MEMO

TO	James Neave	FROM	Jo North/David Vince/Sam Noble
DATE	21 March 2022	CONFIDENTIALITY	Public
SUBJECT	WSCC/052/20 A29 Phase 1 Realignment – Planning Condition 6

This memo summarises the information provided to support the discharge of Planning Condition 6 – Landscaping Scheme

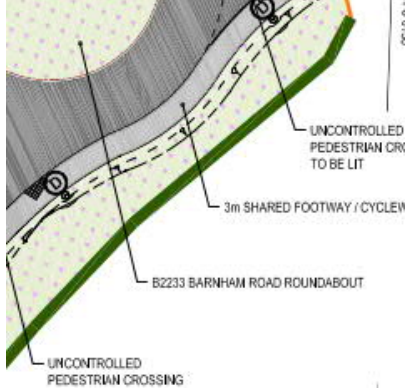
Updates to the landscaping scheme from those submitted with the planning application are described below. Edits to the wildflower meadow grass mix key have been made to identify that topsoil mixing (with subsoil) is being considered in verges and topsoil inversion (topsoil buried in a deeper layer) within the larger areas to reduce nutrient levels which is necessary for wildflowers to thrive.
